# Access Compliance Report

## Public Rights-of-Way

Intersection ID: 43691	Main Street: PORTSTEWART_LN	Cross Street: TEW_CT	Location: NE
ADA ID: AC25C0EC14F4	Ramp Type: BlendTrans1	Initial Pass/Fail: Fail	Overall Compliance: No
Severity Score: 36.25			
Codes/Mitigation Info/Possible Solution		Field Measurements/Component Compliance

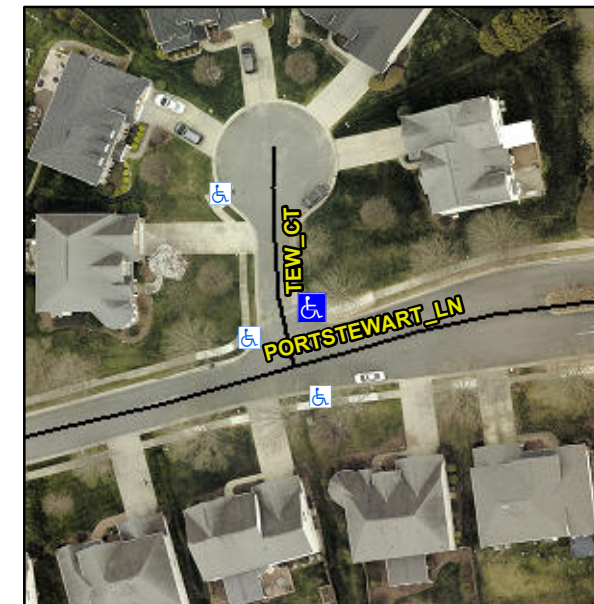
**Not Found, R304.5.1, R304.5.3, R302.7**

Compliance	Description	Data	Compliance	Description	Data
N/A	Ramp Length (in)	51.5	Yes	BlendTrans Slope (%)	3.2
No	Ramp Width (in)	41.0	No	BlendTrans XSlope (%)	6.9
N/A	Flare Type LT	N/A	N/A	Flare Type RT	N/A
N/A	Flare Slope LT (%)	N/A	N/A	Flare Slope RT (%)	N/A
N/A	Flare Traversable LT?	N/A	N/A	Flare Traversable RT?	N/A
N/A	Landing Length (in)	N/A	N/A	DWS Provided?	N/A
N/A	Landing Width (in)	N/A	N/A	DWS Contrast?	N/A
N/A	Landing Slope (%)	N/A	N/A	DWS Length (in)	N/A
N/A	Landing X Slope (%)	N/A	N/A	DWS Full Width?	N/A
N/A	Landing Curb? (Y/N)	N/A	N/A	DWS Offset (in)	N/A
N/A	Shared Landing?	N/A			
N/A	Gutter Ponding?	N/A	N/A	Gutter Slope (%)	N/A
N/A	Gutter Lip Ht (in)	N/A	N/A	Gutter X Slope (%)	N/A
N/A	Painted X Walk1?	No	N/A	Painted X Walk2?	No
	X Walk 1 Direction	To W		X Walk 2 Direction	To S
	X Walk 1 Width (in)	N/A		X Walk 2 Width (in)	N/A
	X Walk 1 Slope (%)	3.5		X Walk 2 Slope (%)	4.0
	X Walk 1 X Slope (%)	5.1		X Walk 2 X Slope (%)	5.2

N/A	Ramp inside XWalk1?	N/A	N/A	Ramp inside XWalk2?	N/A
	Road Slope (%)	6.4		Clear Space?	N/A
	Road X Slope (%)	2.0	N/A	Clear Space to XWalk (in)	N/A
N/A	Any Obstructions?	N/A	N/A	Storm Grate/Utility Hazard?	N/A
	Obstruction Type			Storm Grate/Utility Type	
		N/A			N/A
		No		Surface Condition? (G/P)	Poor
		No		Curb Slope (%)	10.5

**Remove & Replace Curb Ramp With Two New Directional Ramps or Equivalent.**
